SERVICE BULLETIN

Number: SB9508-16

Subject: Final Adjustment on Belt-Drive Walk-Behinds

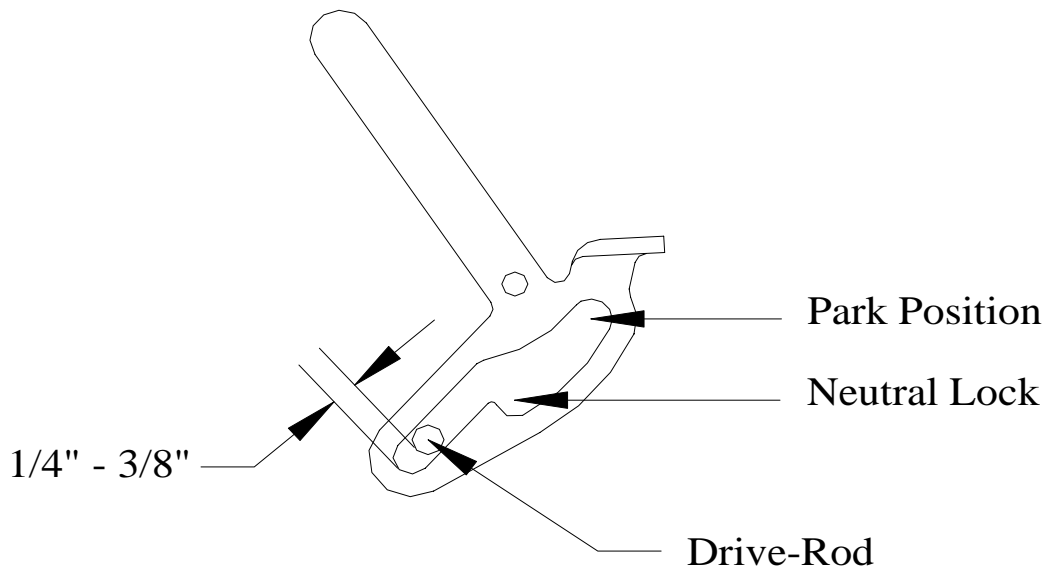
When making the final adjustments on thumb locks, make certain that there is 1/4" to 3/8" clearance between the drive rod and the bottom of the thumb lock. After setting the clearance, lock the thumb lock into the neutral position and adjust the brake so that there is a slight resistance. Replace swivel into idler and replace hairpin cotter.

With thumb lock still in neutral position, you should be able to roll the mower freely. Now rotate the thumb locks all the way back. The brakes should now hold the mower from moving. This is the park position or the way to engage the parking brake.
